Community Development Department Memorandum

SUBJECT: Public Hearing, SSI Technologies Inc. request for the reduction of a plant screening requirement (from 80 feet to 40 feet) on property located at 3330 Palmer Drive.

February 23, 2010

SUBJECT: Review of a site plan for a building addition to be constructed on the north side (front) of the existing building, SSI Technologies, Inc., 3330 Palmer, Janesville, Wisconsin

NORTH
OVERALL SITE
SCALE: 1" = 60'-0"

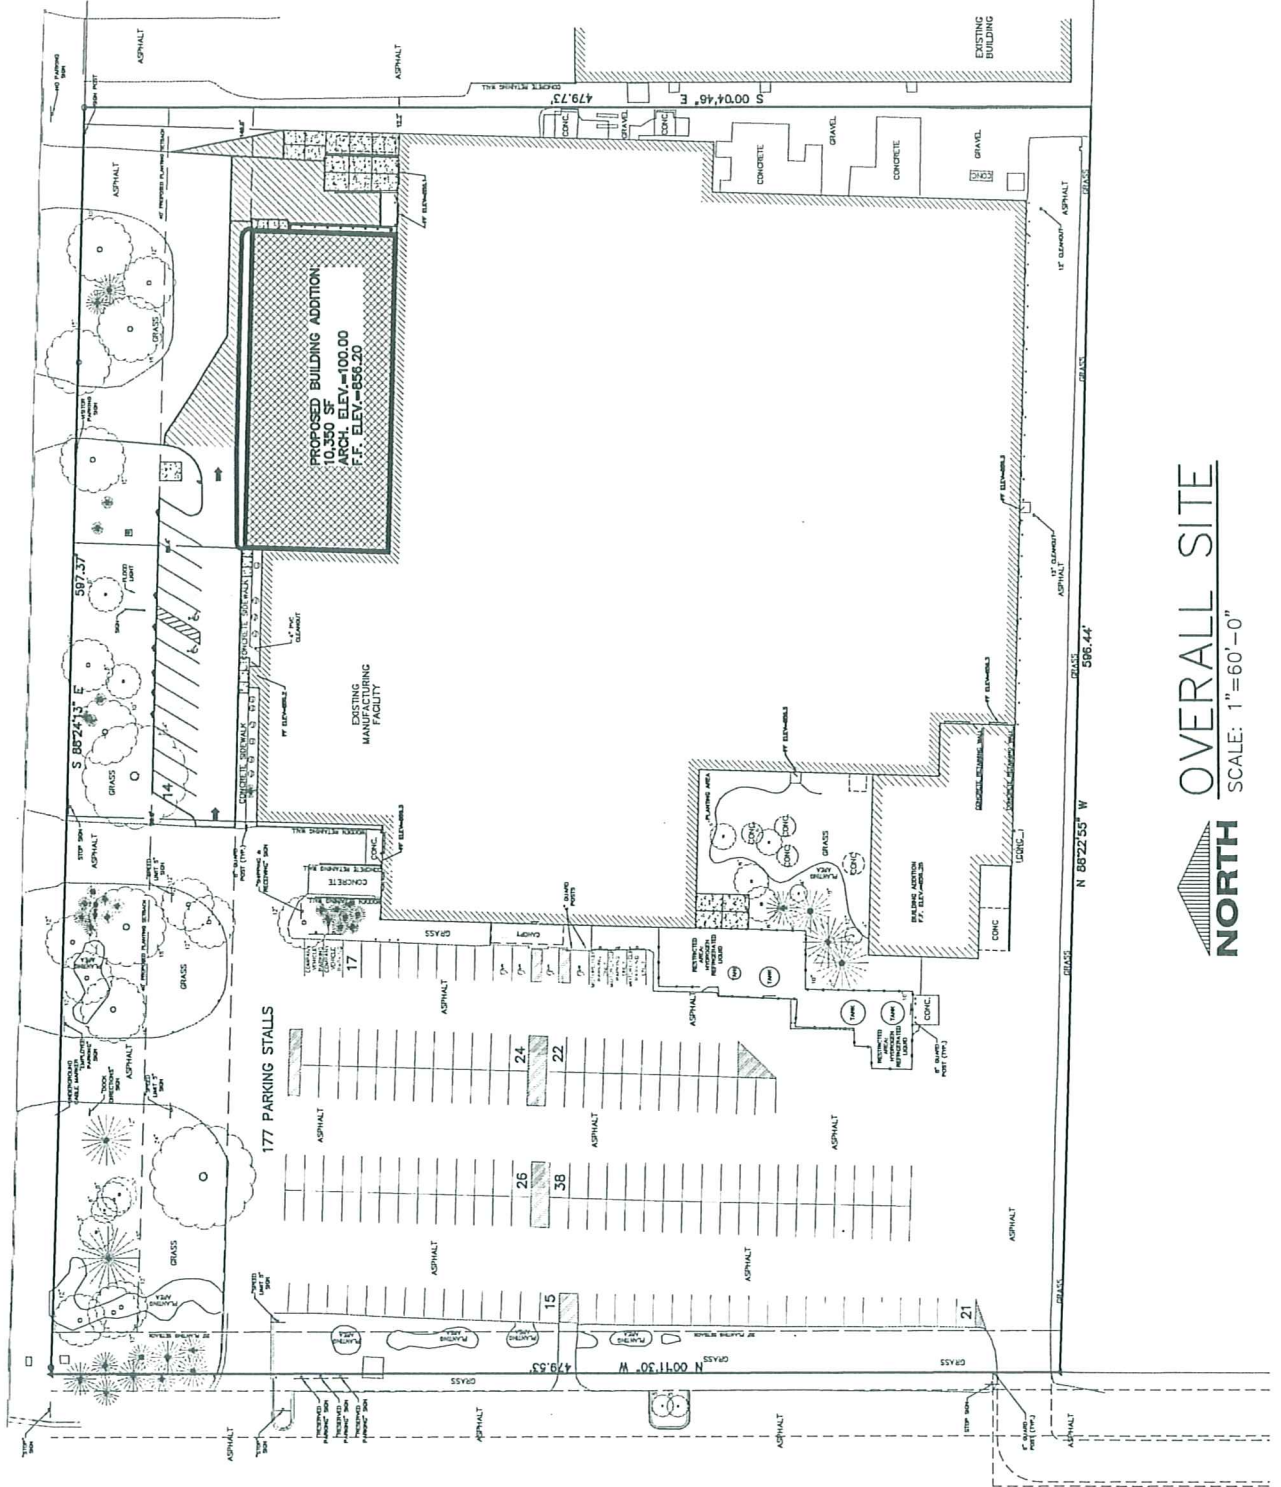
1. There is an 80 foot wide plant screening strip restriction along the north property line in which no improvement other than the curb openings/approaches may be placed. The proposed building addition would be setback 80.3 feet from the front property line; therefore, upon building plan review and approval, a permit for the addition may be issued. However, the site plan shows encroachments (parking/paving) in the 80 foot strip which is not allowable and a reduction in the requirement must be approved in order to go forward with your proposal for the parking in front of the building. The proposed affidavit instrument to reduce the requirement from 80 feet to 40 feet has been submitted and the Plan Commission will review your request at the March 1st meeting. The Plan Commission will forward a recommendation to the City Council which will be reviewed at the following City Council meeting on March 8th.

5. When provided parking exceeds 151 stalls, six Barrier free parking stalls are required. Please note that the two new handicap stalls and loading zoning proposed at the front of the building must meet the applicable standards and be properly signed prior to an occupancy permit being issued for the addition. If the screening reduction is not approved, these stalls must be relocated within the existing parking lot.

6. The one-way drive aisle proposed for the front of the building must be appropriately signed and provided with pavement markings in order to ensure that traffic travels through this lane in a one-way eastward pattern. A "Do Not Enter" sign must be installed as designated in the attached drawing.

Larry Hainstock, Fire Inspector has approved the one point in the drive aisle where it narrows to 17 feet; however, please note that the drive aisle does not meet standard fire lane widths and it must be kept completely clear of obstacles at all times (ex: snow cannot be allowed to build up along the curbs).

9. The proposed landscaping in front of the new parking stalls (parallel to the 40 foot screening border) is not adequate to screen vehicle headlights from the residential neighbors to the north.

14. The site plan shows the relocation of the gas meter and electric transformer from the existing building; however, there is no provision shown for the relocation of the fire hose (siamese) connection which is only shown on the demolition page of the plan. Please revise the site plan to show where this will be relocated and its distance from the nearest fire hydrant (150 feet or less). Separate plan review is required. Please contact Fire Inspector Larry Hainstock at 755-3056 for additional information.

Please submit a revised landscaping plan which provides a solid combination of yews and arbutus (at least 42 inches tall at time of planting) in front of the new parking spaces. Dogwoods or burning bushes may be intermingled to add color to these areas. In addition, please revise the plan to more adequately screen the electric transformer from view.
